Mooney Mite Series M-13
Service Bulletin No. 14

MOONEY AIRCRAFT, INC.
M-18 SERVICE LETTER NO. 15

M-18 SERVICE LETTER NO. 16

M-18 SERVICE LETTER NO. (17)

FIG. 1

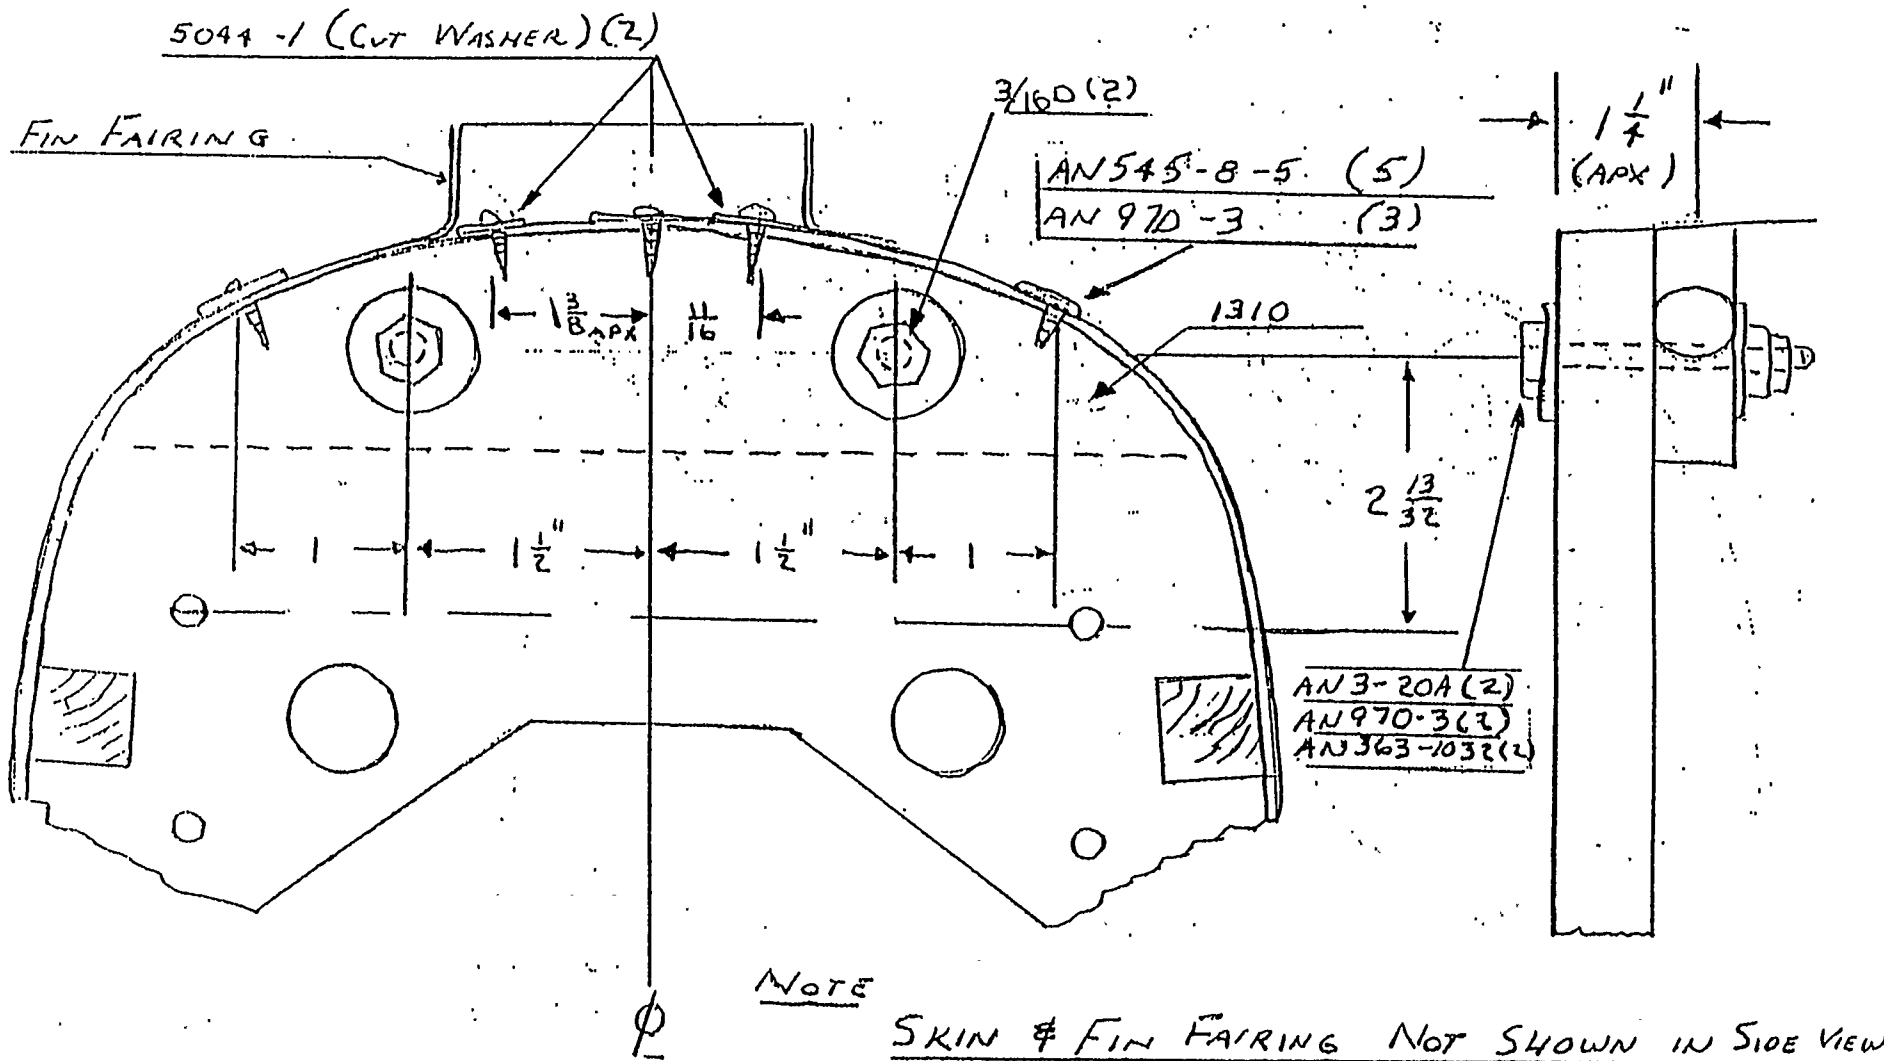
1. All airplanes having the defect described in Item 1 of the Introduction are to be repaired in accordance with Figure 1 or Figure 2 depending on the type of elevator control system.
2. Order Rework Kit SL 18-17-1.

FIG. 4

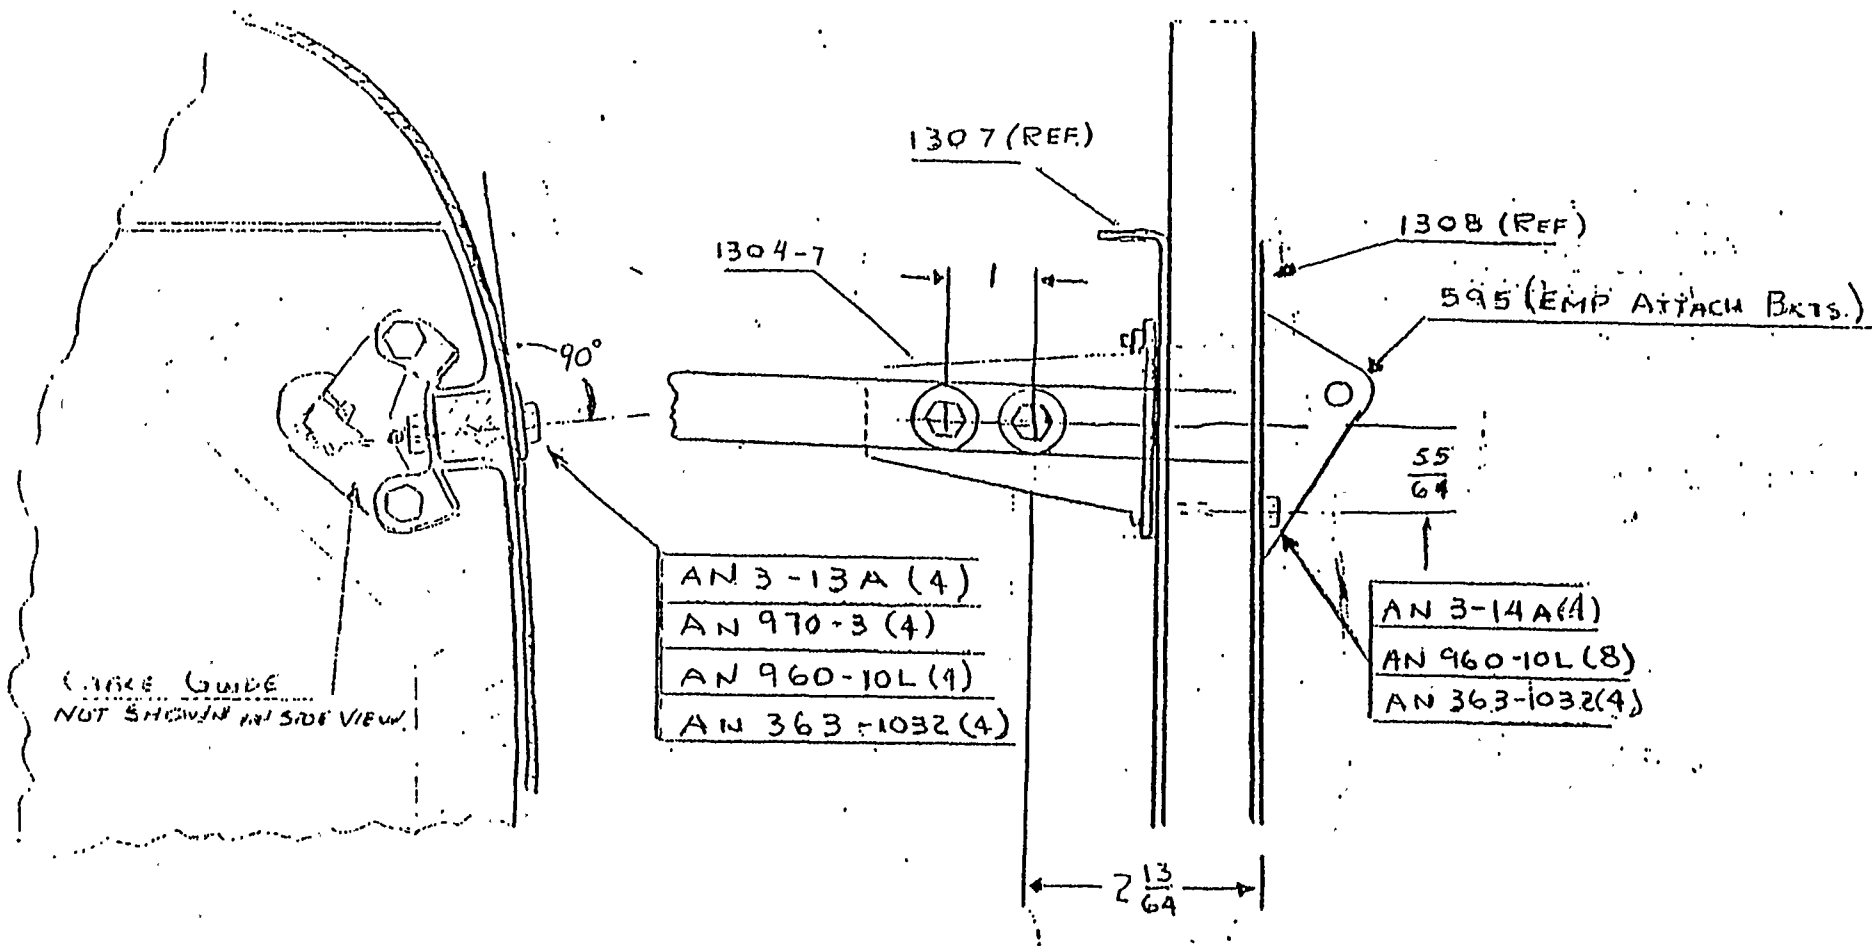
1. For all airplanes not having P/N 1157-1/-2 clips installed, the following must be accomplished after compliance with Part B:
 - a. Mark the location on the outside of tail cone of the four holes through the upper longeron as shown on Figure 4.

- c. Install P/N 1309-7/-8 fittings, empennage attachment brackets and cable guides as shown in Figure 4.
 - d. Block fittings to prevent play and, using 1/8 diameter holes as guides, drill 11/64 diameter holes (4) through longerons and 1309 fittings. Using 11/64 diameter holes as guides, drill out holes to 3/16 diameter.

- e. Bolt the 1309-7/-8 fittings to the longerons as shown in Figure 4. Exercise care in tightening bolts so as not to crush wood.

FIG 5

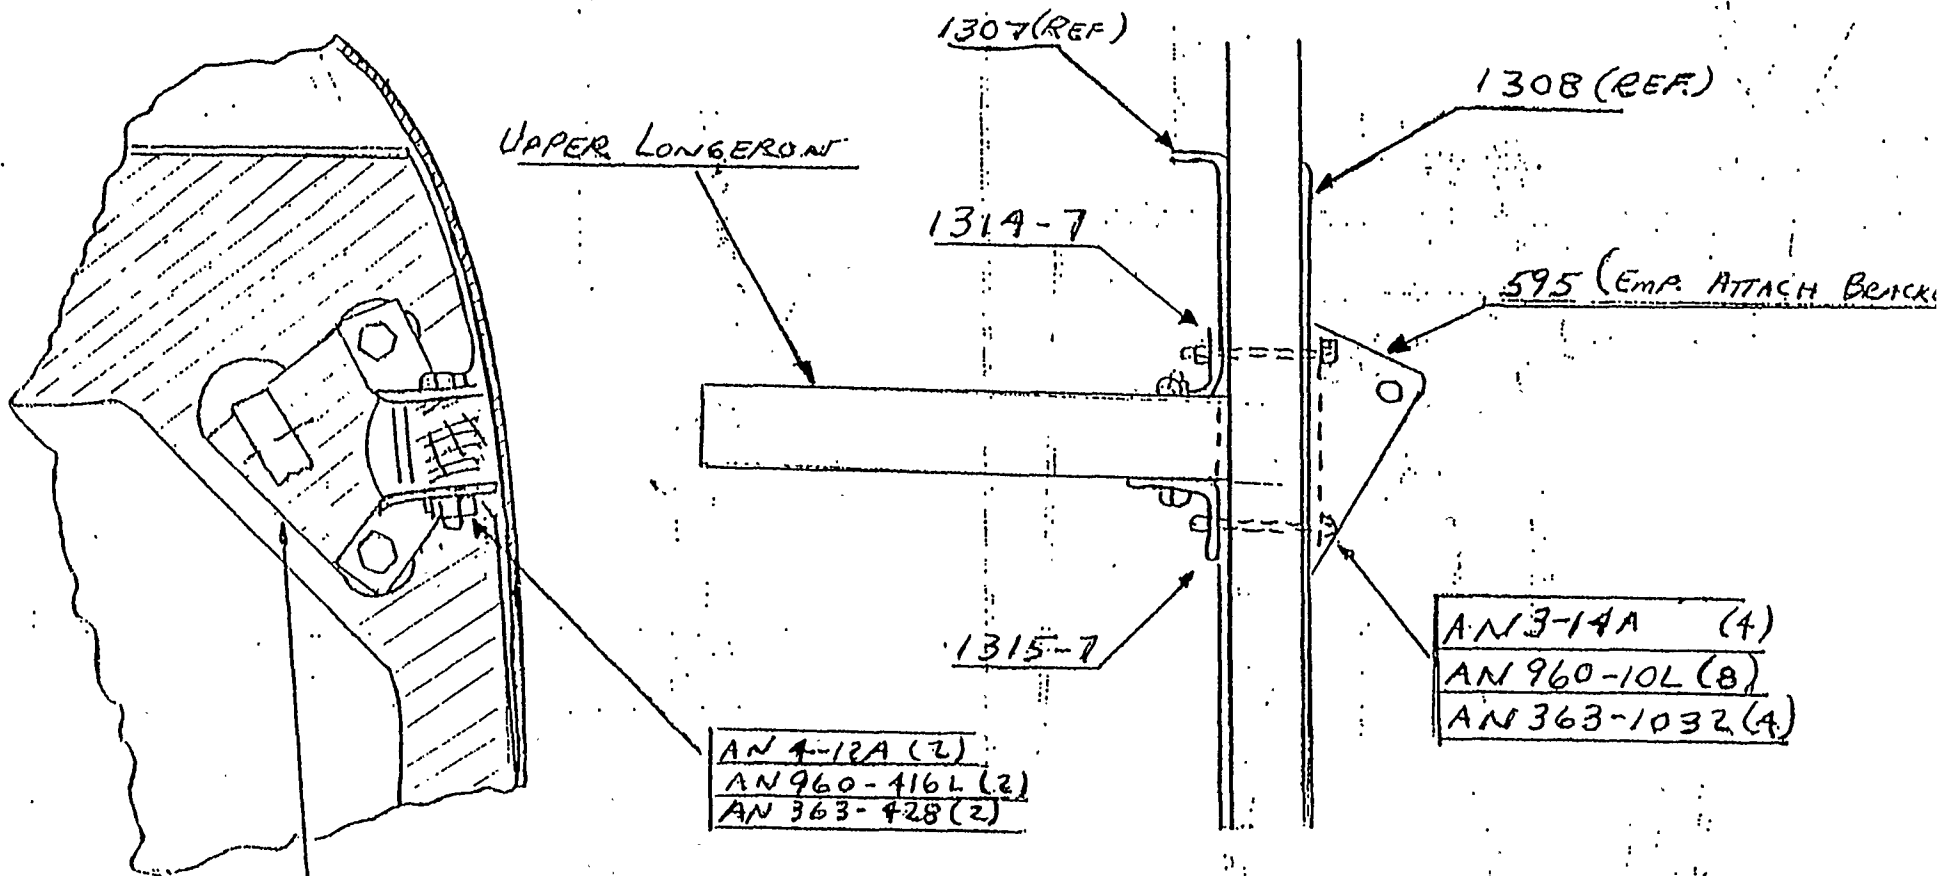
1. For airplanes which had P/N 1157-1/-2 clips installed and which have been reworked in accordance with Part E, the following shall be accomplished:
 - a. Reinstall empennage attachment brackets and cable guides and replace P/N 1157-1/-2 clips with P/N 1314-7/-8 clips and add P/N 1315-7/-8 clips on lower side of upper longeron picking up lower bolt of empennage attachment brackets as shown in Figure 5. Install vertical bolt through two clips and longeron as shown.

FIG. 6

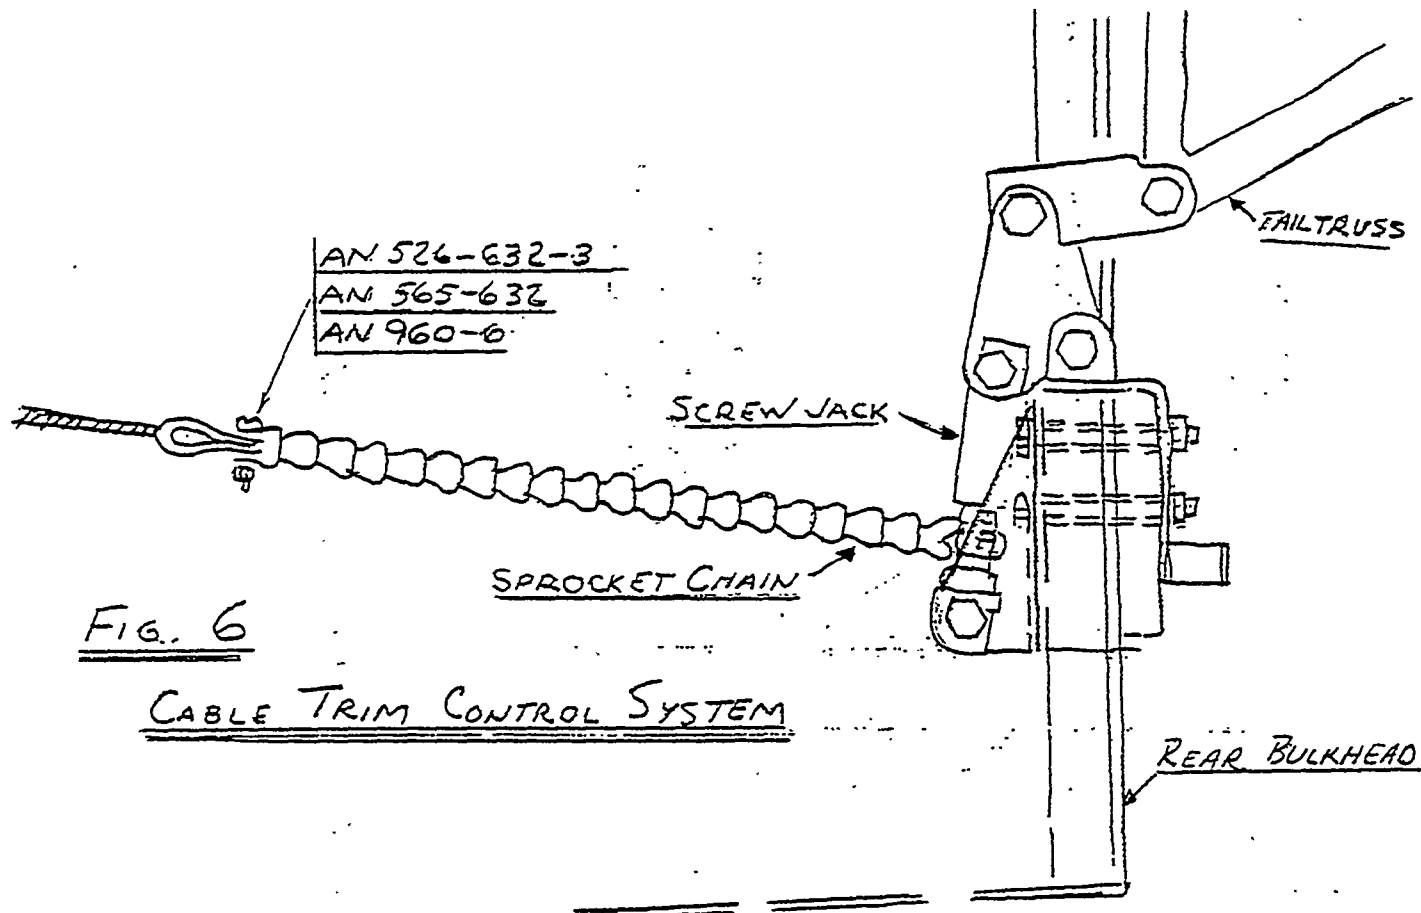
- (3) For airplanes equipped with a cable control trim system, the adjustment is made as follows:
 - i. Remove chain from screwjack by removing bolt connecting sprocket chain to cable on one side. See Figure 6.

- ii. Turn screwjack at sprocket until the leading edge of vertical fin is inclined forward 3.5° to vertical reference.
 - iii. Reinstall chain around sprocket and connecting bolt to cable end.

- iv. Check "nose down" trim position for vertical fin leading edge inclination rearward of 1.5° to vertical reference.
 - (4) For airplanes equipped with push-pull rod trim control system forward of the rear bulkhead, the adjustment is made as follows:

FIG 7

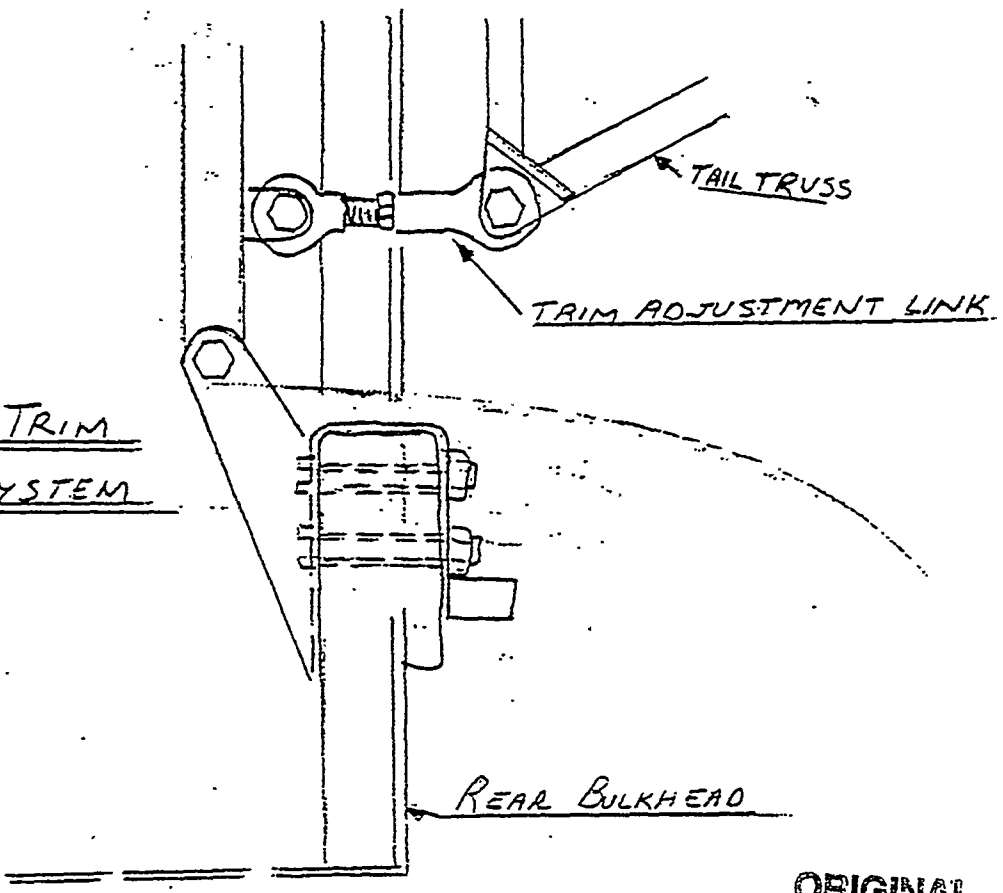
- i. Adjust heim bearing of trim adjustment link shown in Figure 7 until leading edge of vertical fin is inclined forward 3.5° with trim setting in "nose up" position.

- ii. Check inclination of leading edge of vertical fin for 1.5° rearward for trim in "nose down" position.
